PROJECT
The Medical Center of Aurora
Hybrid OR 9
1501 S. Potomac St.
Aurora, CO 80012

Revision #1-5: Date of Issuance: 3-3-2021

Project Number: 190318

The items below are revisions 1-5 to the original Construction Documents dated 01/14/2020. Revisions described below and indicated on the attached revised plans:

SHEET NO.:
G101

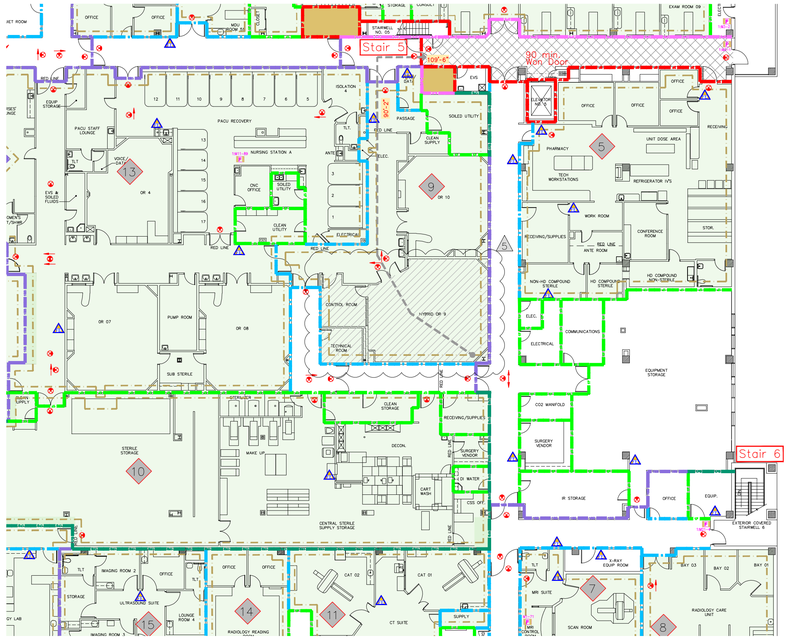
1. Enlarged plan shows completed construction background with updated life safety.

SHEET NO.:
AD101

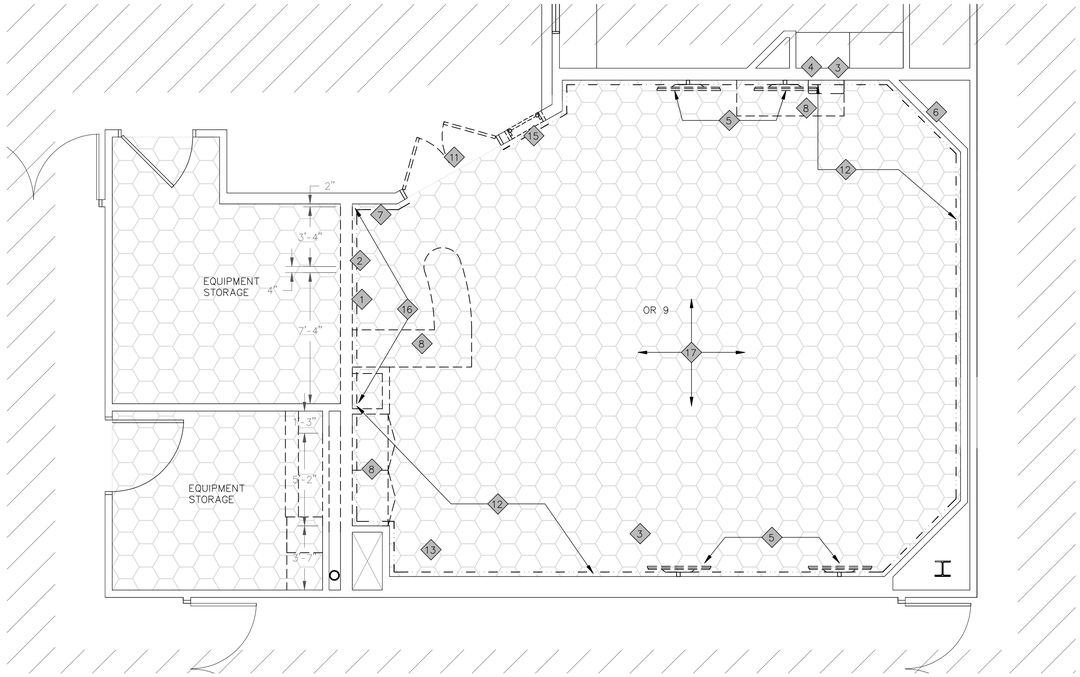
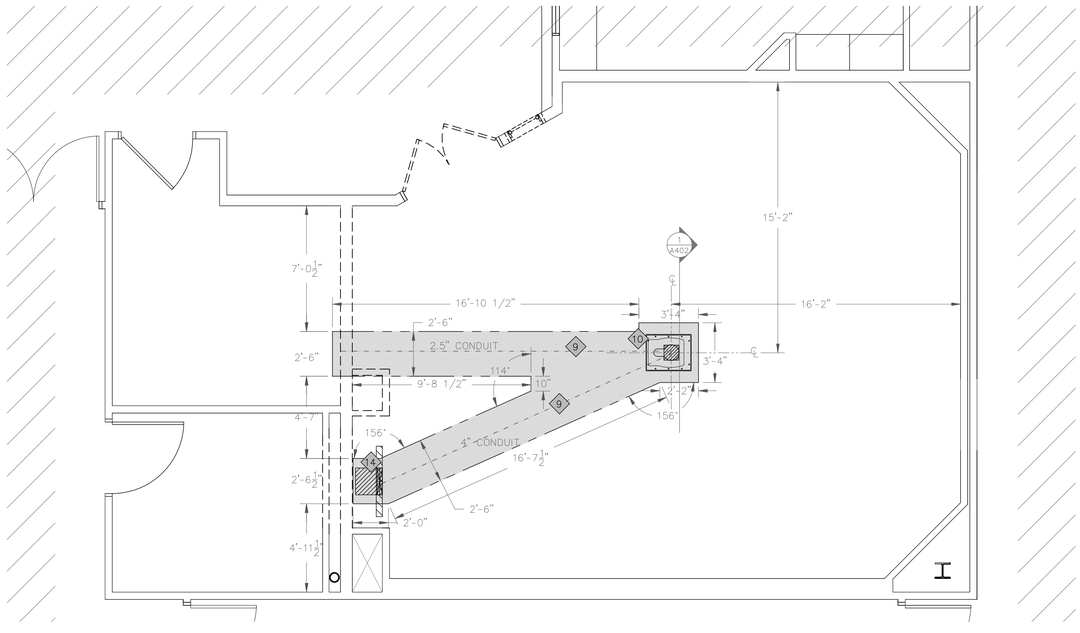
AD101 – Demolition Plan / Conduit Trench Plan
1. Contractor to remove device covers where existing dry wall is to be replaced with lead-lined drywall.
2. Clarification on existing door demolition.
3. Plan notes with dimensions for wall section removals.
4. Added note for contractor to anticipate substantial floor grinding & floating to meet floor specification requirements.

SHEET NO.:
AD102

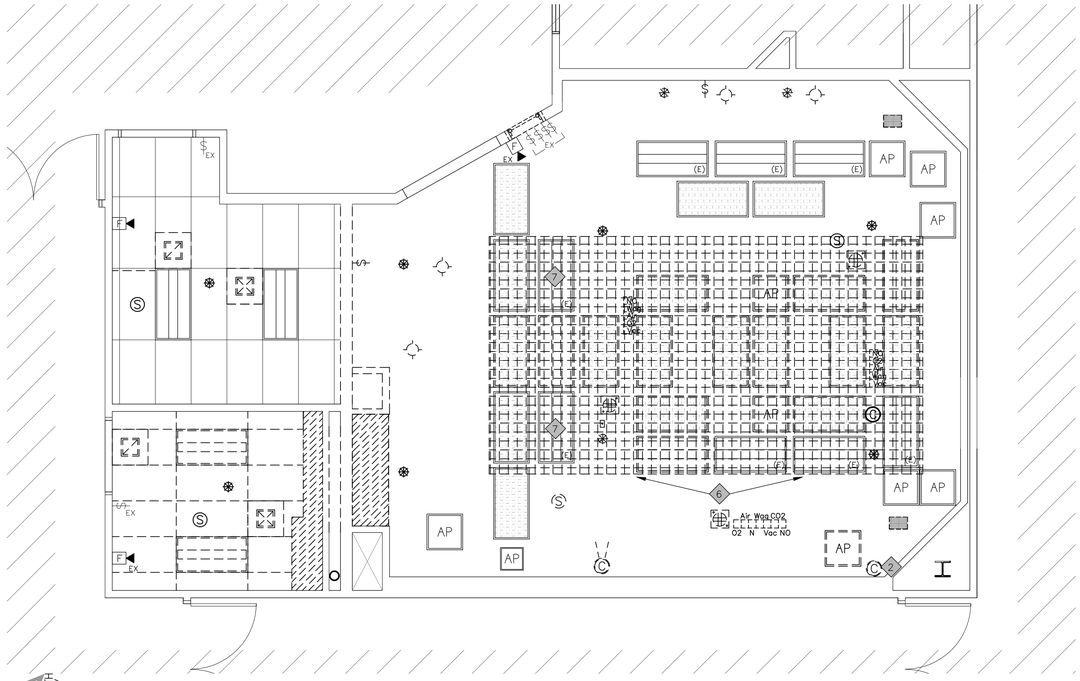
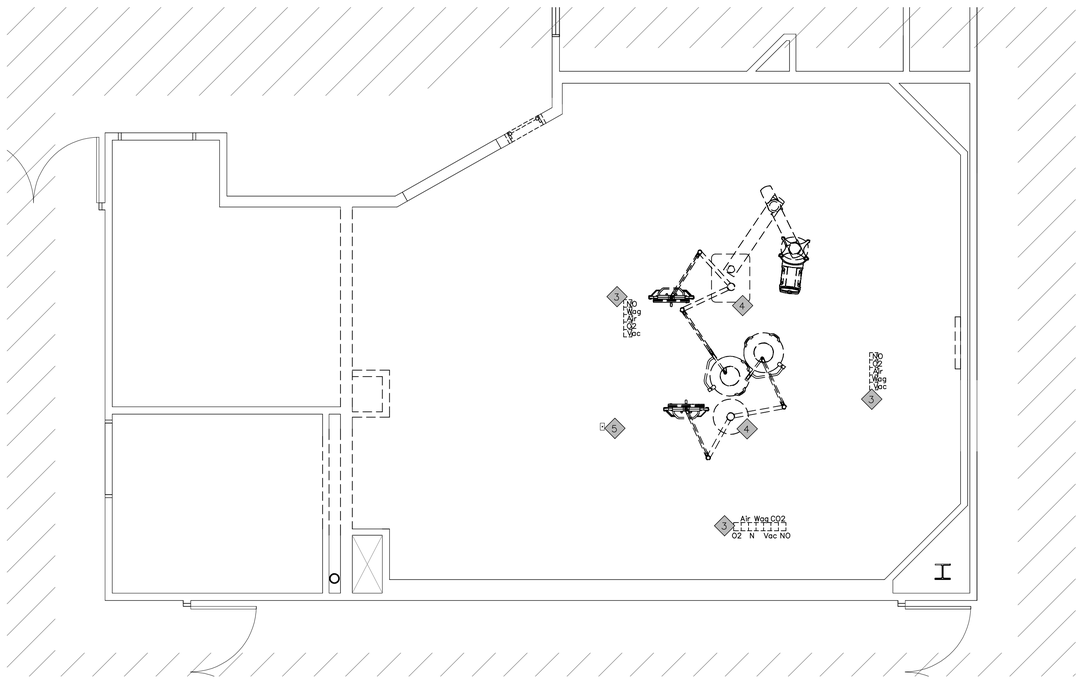
AD102 – Ceiling Demolition Plan
1. Clarification on limits of existing ceiling demolition area.
2. Additional notes for managing existing ceiling devices.
3. Light fixture removal note.

AD102 – Ceiling Demolition Plan: Removed keynote 1, existing clock/timer back box opening are to remain.

SHEET NO.:
A101

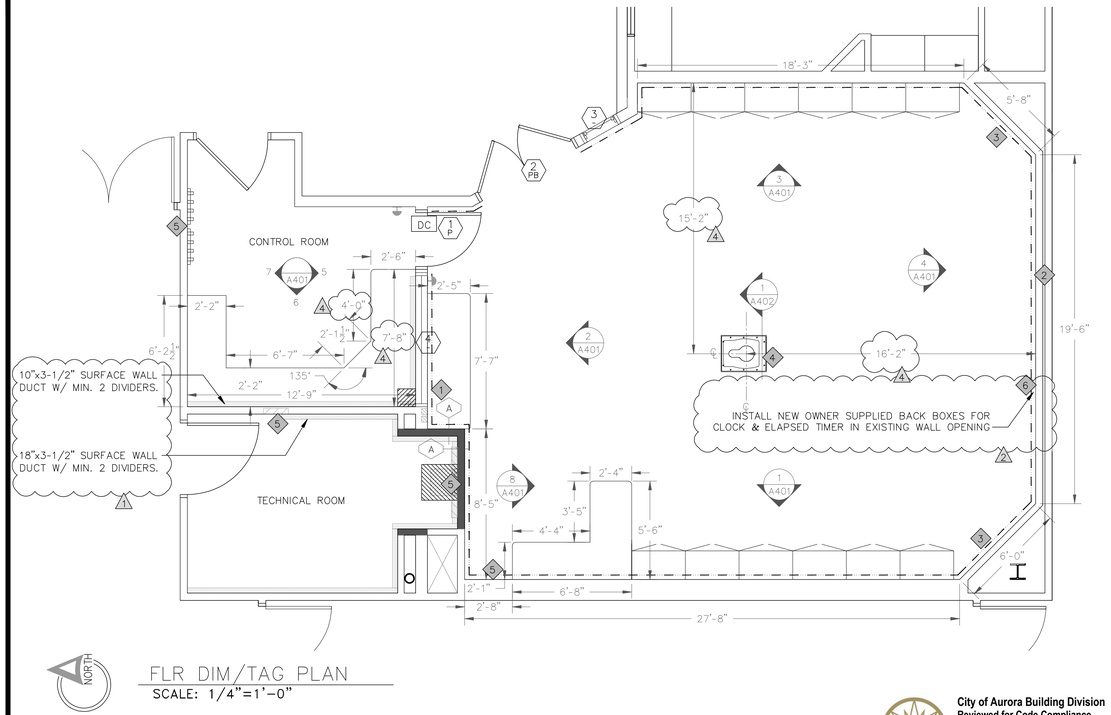
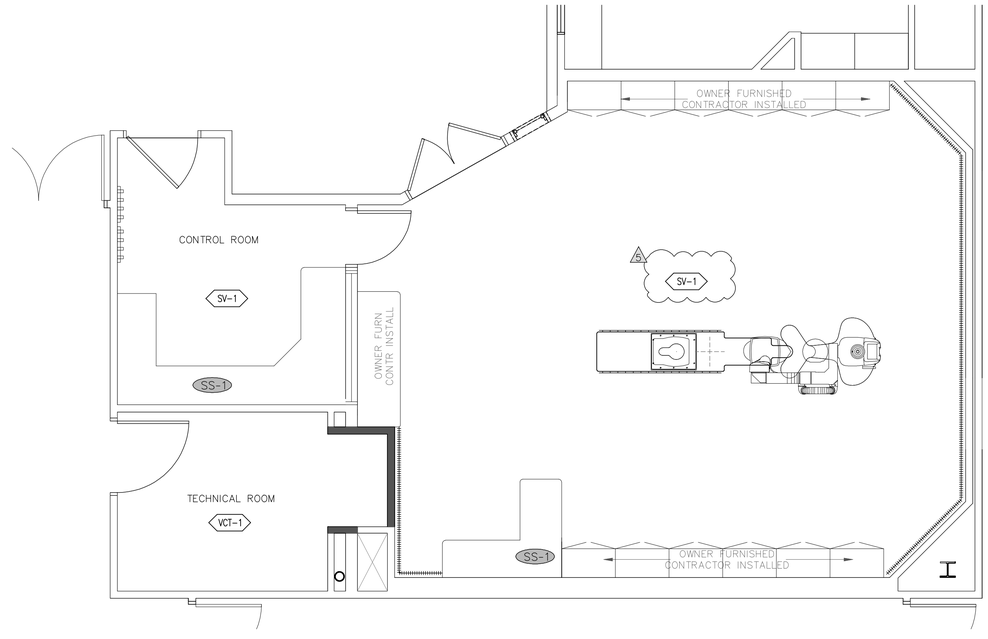
A101 – Floor Dim/Tag Plan, Finishes Plan
1. Locations shown for new surface mounted wall duct.

2. Floor finishes plan revised to include an eight inch border of the Silikal material along perimeter wall of procedure room with additional flooring notes.
3. New door and window hardware changes and descriptions.
4. New paint type and color added for the procedure room ceiling.

A101 – Floor Dim/Tag Plan, Finishes Plan: Relocated keynote 6 to existing clock/timer location for contractor to install new back boxes.

1. Control room lead-lined window added to door/glazing schedule.
2. Procedure room ceiling paint specification change.
3. Casework and control dimensions updated per site verifications.

1. Flooring specification change in Control Room & Procedure Room.

SHEET NO.:
A102

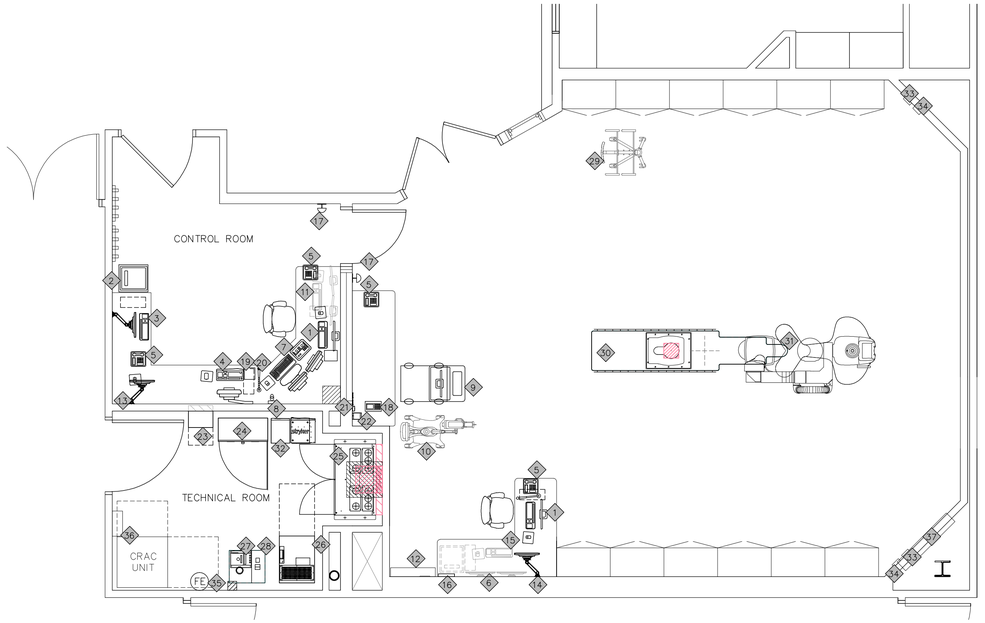
1. New keynote showing existing isolation panel location.
2. Added note for contractor to coordinate with flooring contractor regarding millwork installation and flooring rolled base.
3. Additional general note referencing roof penetration curb detail.

SHEET NO.:
A103

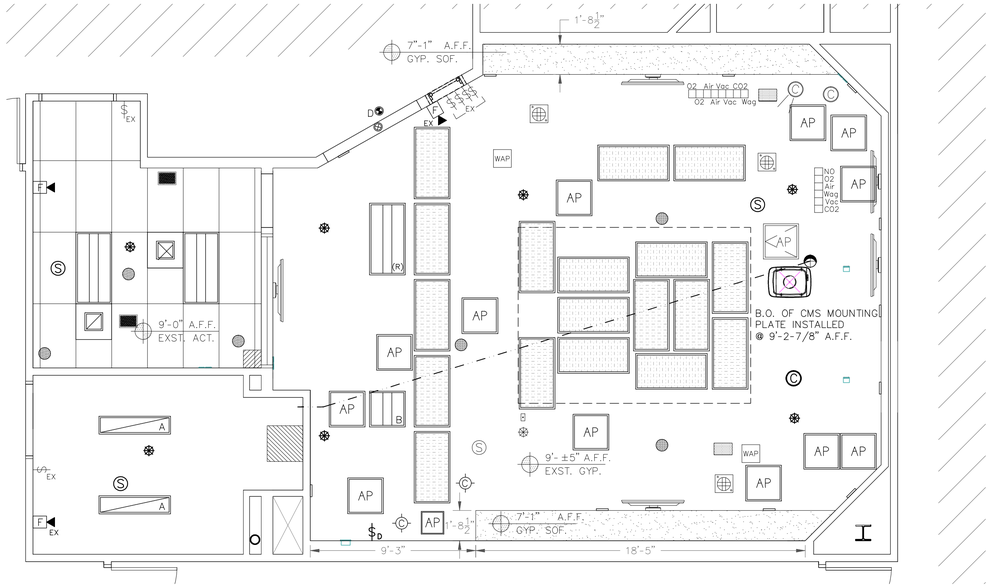
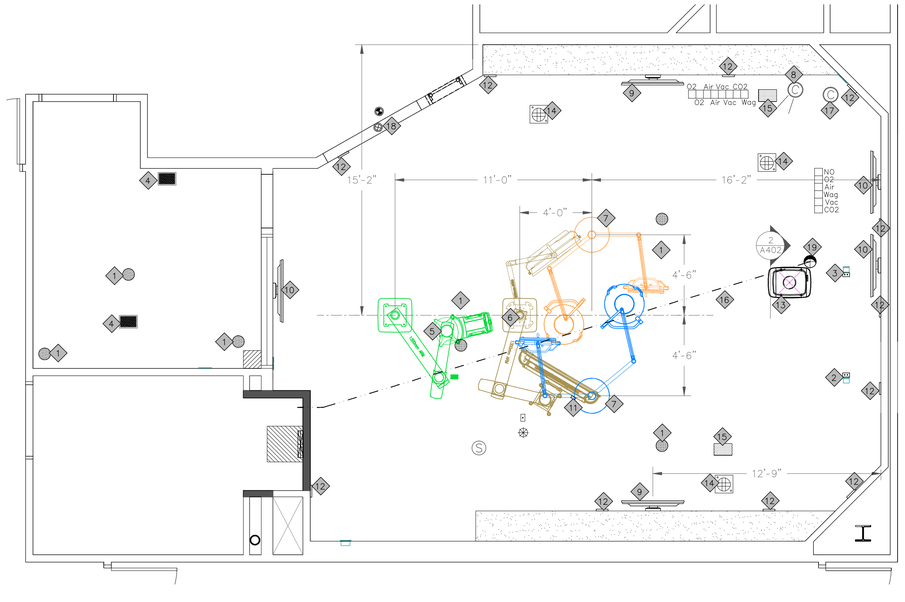
1. Note referencing new paint selection for OR ceiling.
2. Clarification note for contractor's requirement for mounting fabricated structural plate to GE CMS mount.

SHEET NO.:
A401

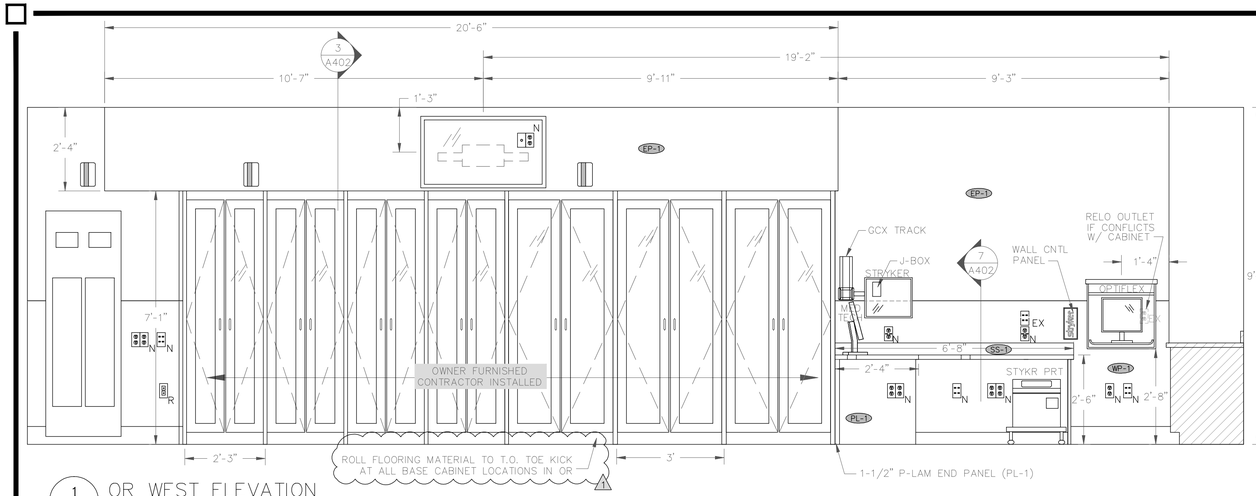
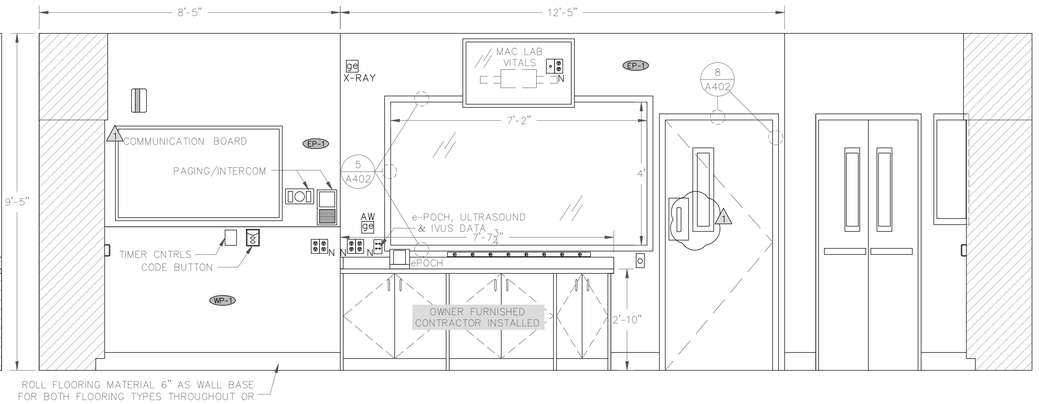
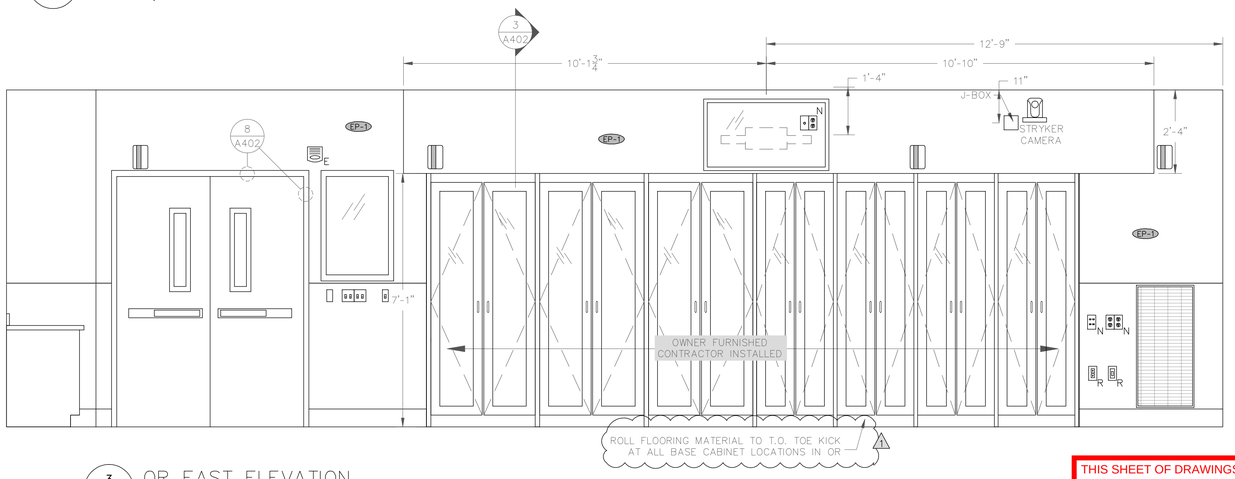
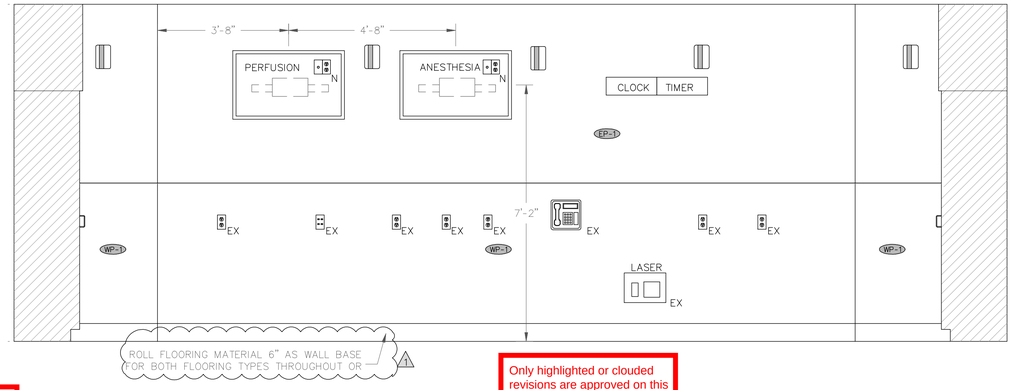
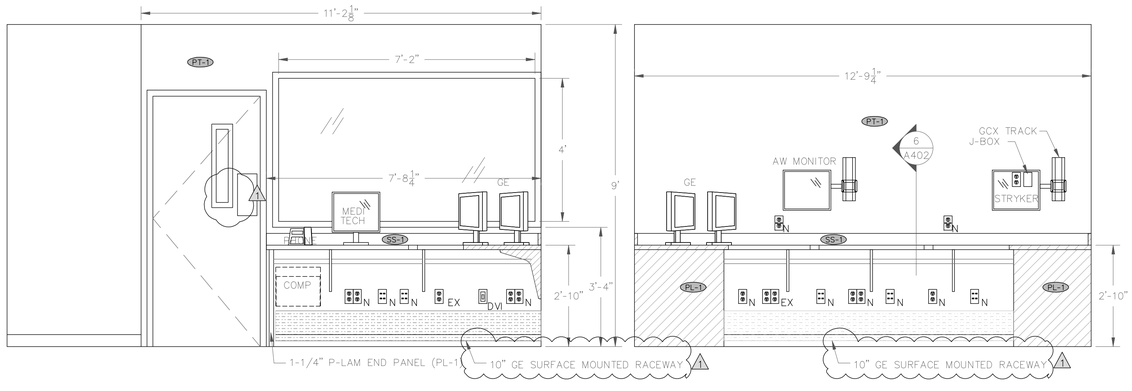
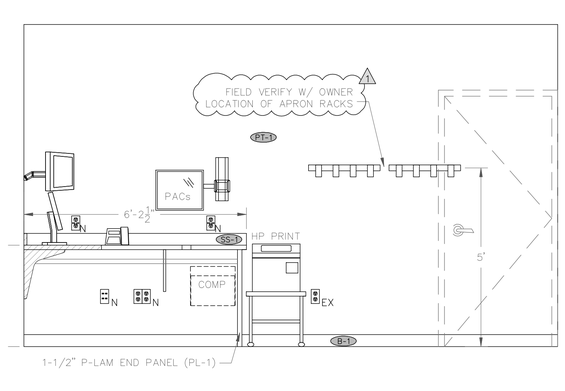
1. Added note and locations for rolled floor wall base.
2. Hospital supplied communication dry erase board mounting location
3. New push/pull door handle hardware shown on single door as a replacement to the latching lever set.
4. Note added for contractor to work with owner on lead apron rack placement for proper wall backing.
5. Surface mounted wall duct shown in elevations.

A401 – Elevations: OR North Elevation #2 – Removed previously proposed clock/timer location from drawing.

1 9 A402 ROOF PIPES PENETRATION
SCALE: NTS

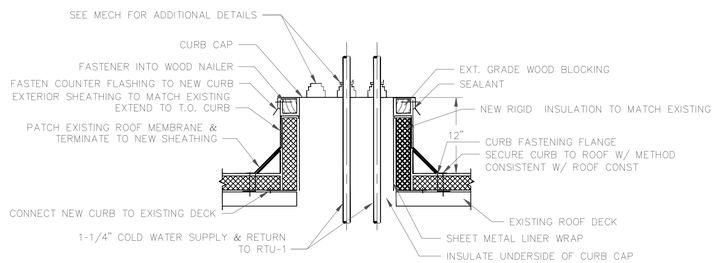
1. New roof pipes penetration curb detail.
